**PLANNING COMMISSION MEETING
AGENDA
CITY OF WHITE BEAR LAKE, MINNESOTA**

- A. **North Campus EAW: Case No. 21-1-EAW:** A request by the **City of White Bear Lake** for review and acceptance of the Findings of Fact and Conclusions of the Environmental Assessment Worksheet (EAW) prepared for the North Campus High School Expansion Project at the property located at 5045 Division Avenue.

- B. **Case No. 21-3-CUP:** A request by **Independent School District #624** for a Conditional Use Permit, per Code Section 1303.245, to allow expansion of the existing North Campus public high school located in the P – Public zoning district at the property located at 5045 Division Avenue.

- C. **Case No. 21-4-CUP & 21-5-V:** A request by **Jacob & Chandler Ommen** for a Conditional Use Permit for a home accessory apartment, per Code Section 1302.125, and the following five variances,

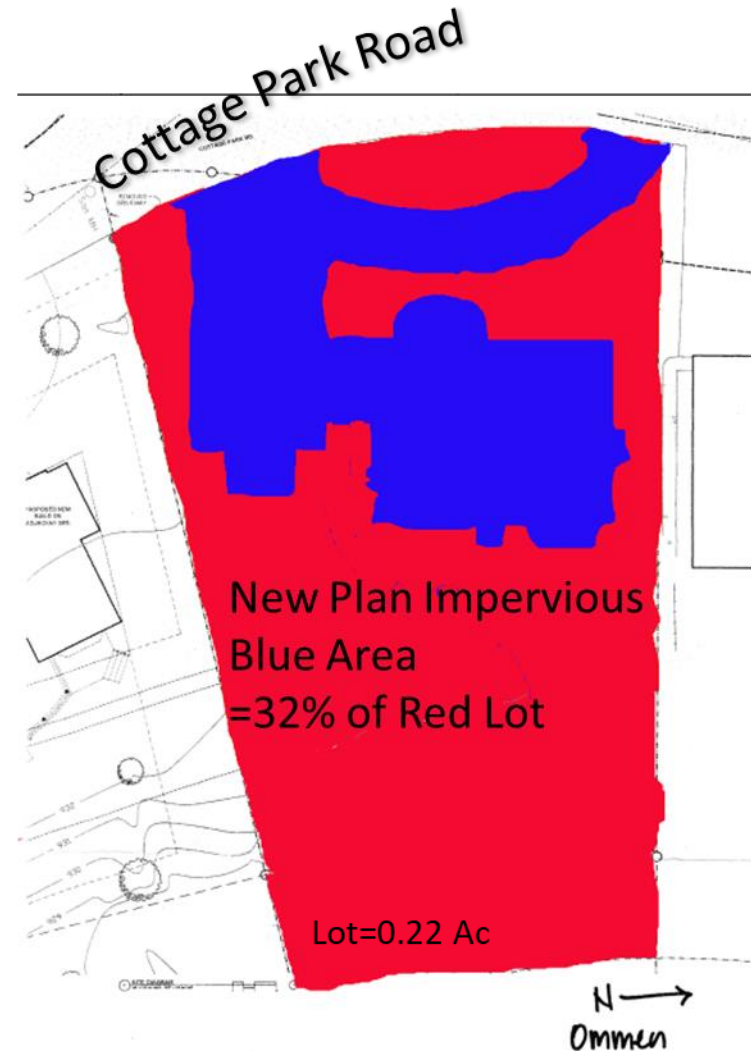
Question 4 relative to request for variance 4320 Cottage Park Road Case 21-4 CUP.

- My rough estimates show existing+new building area has more impervious surface.

Who has the #'s and who verifies Impervious Area calculations? What is White Bear impervious spec for shore land? DNR states it is 25% max of lot area, DNR includes decks in impervious areas.
